**American Centrifuge Lead Cascade Facility  
Docket Number 70-7003; License Number SNM-7003**

**Submittal of Changed Pages of the Emergency Plan for the American Centrifuge Lead Cascade Facility**

**Changed Pages of the Emergency Plan for the American Centrifuge Lead Cascade Facility**

Figure 1-2 PORTS Plant Layout

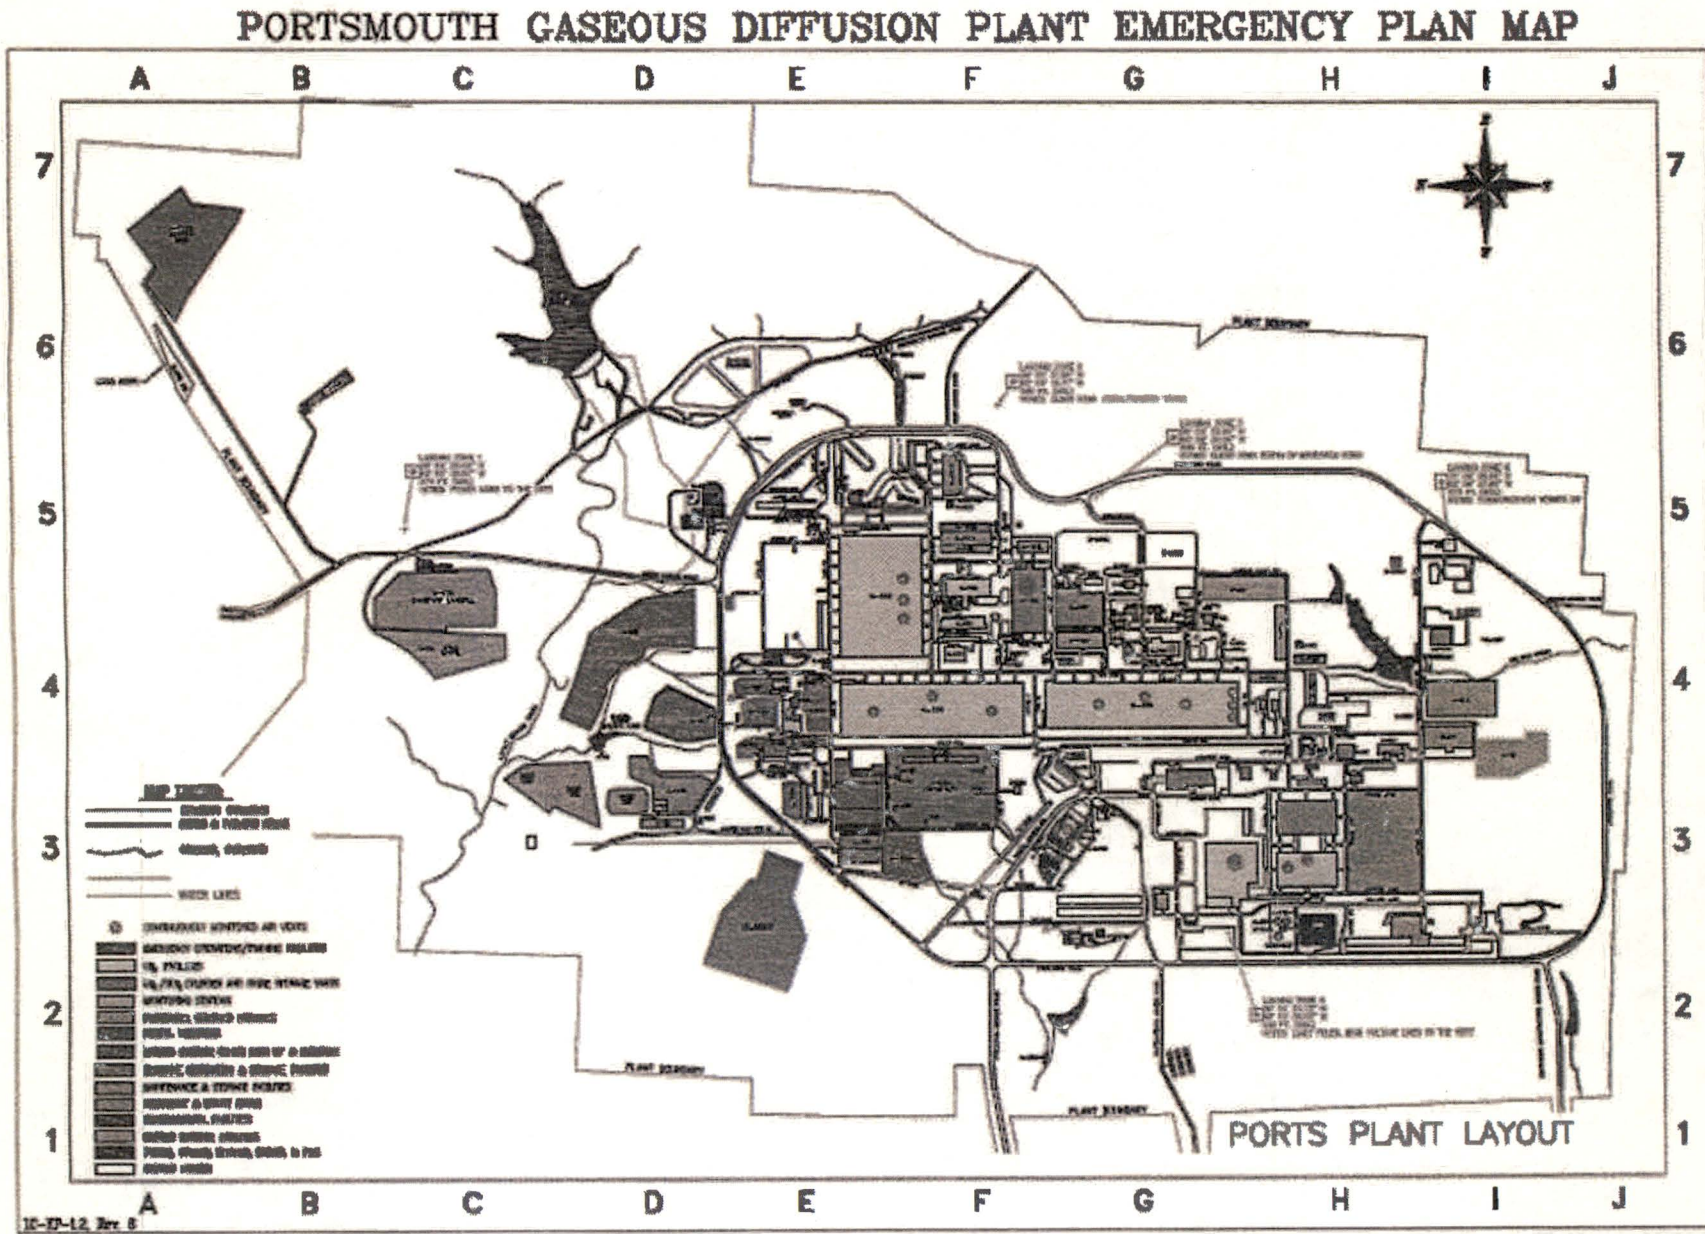
The changes noted in Enclosure 1 have been reviewed in accordance with 10 CFR 70.32 and have been determined not to decrease the effectiveness of the applicable plan. Revision bars in the right hand margin depict changes from the previous revision submitted to the NRC.
